Contract #: 04-0120F4
 Cty: SF/ALA Rte: 80 PM: 13.2/13.9
 File #: 69.25B

QUALITY ASSURANCE -- NON-CONFORMANCE REPORT

Location: Changxing Island, Shanghai, China **Report No:** NCR-000894
Prime Contractor: American Bridge/Fluor Enterprises, a JV **Date:** 22-Nov-2010
Submitting Contractor: Zhenhua Port Machinery Company, Ltd (ZPMC), Changxing Island **NCR #:** ZPMC-0856

Reference Description: Heat Straightening Performed without Prior Approval From Engineer

Welding	Concrete	Other	
Welding	Curing	Procedural	Bridge No: 34-0006
Joint fit-up	Coating	Other	Component: Lift 14W Anchorage Plate AP3032A
Procedural	Procedural	Description:

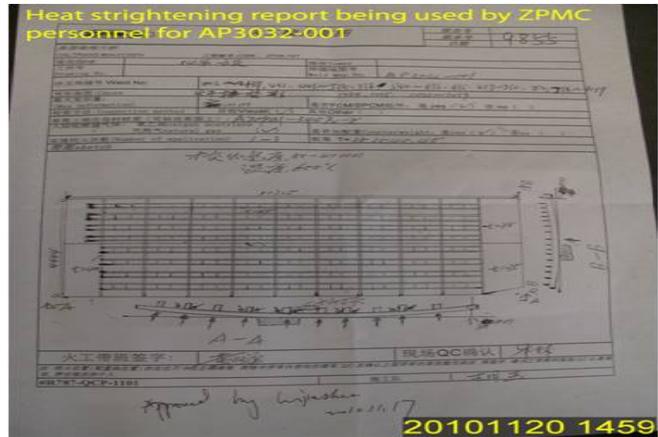
During the Quality Assurance Daily Observation of fabrication heat straightening of AP3032-001 this Quality Assurance Inspector (QA) discovered the following issues:

- ZPMC personnel heat straightening excessive distortion on Seismic Performance Critical Material (SPCM) material distorted by welding without the Engineers approval.
- ZPMC appeared to be following Heat Straightening procedure HSR1-(B)-9855
- The component is identified as AP3032-001.
- The plates that heat was being applied to were X5055A and X5055B.
- The OBG anchorage plate AP3032-001 is located in Bay 2.

- The Material thickness is 35mm.

Special Provisions Section 8.3 – “For material more than 16 mm, the Contractor shall not heat straighten members more than 3 in 1000 without prior approval of the Engineer.”

AWS D1.5M – 2002 section 1212 Straightening, Curving, and Cambering – “Exceptions to the provisions of this subsection shall require the Engineer’s approval.”

AWS D1.5M – 2002 section 3.7.3 Repairs – “Members distorted by welding shall be straightened by mechanical means or by carefully supervised application of a limited amount of localized heat as approved by the Engineer.”

According to the Special Provision Clause 10-1.59 'Structural Steel, material greater than 16mm in thickness the ratio of distortion allowed is 3 in 1000 mm before Engineer approval is required. The plate length is 10315 mm and the measured distortion is 30mm which is within the tolerances for using an HSR1. Contractor does not consider this is non-conforming and proposes no corrective action is required.

Following clarification by ZPMC and discussion involved all parties including QA personnel from Department and ABF the misunderstanding on the exact measurements has been resolved. The QA was satisfied that the distortion measurements were within the allowed tolerance as defined in the Contract and accepted that the correction can be performed as per the Correction Procedure. No corrective action is required.
